REGULATION NO. 52. UNIFORM PROVISIONS CONCERNING THE  
 CONSTRUCTION OF SMALL CAPACITY PUBLIC SERVICE VEHICLES

PROPOSAL OF AMENDMENTS TO REGULATION

TRANS/WP.29/725

DRAFT SUPPLEMENT 2 TO THE 01 SERIES OF AMENDMENTS TO REGULATION NO. 52

"5.7.4. Access to escape hatches

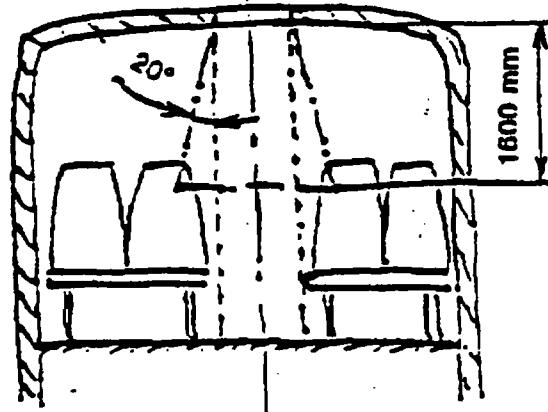
Paragraph 5.7.4., amend to read:

5.7.4.1. If an escape hatch is fitted in a Class B vehicle, at least one escape hatch shall be located such that a four-sided truncated pyramid having a side angle of  $20^\circ$  and a height of 1,600 mm touches part of a seat or equivalent support. The axis of the pyramid shall be vertical and its smaller section shall contact the aperture area of the escape hatch. Supports may be foldable or movable provided they can be locked in their position of use. This position shall be taken for verification.

5.7.4.2. When the structural thickness of the roof is more than 150 mm, the smaller section of the pyramid shall contact the aperture area of the escape hatch at the level of the outside surface of the roof."
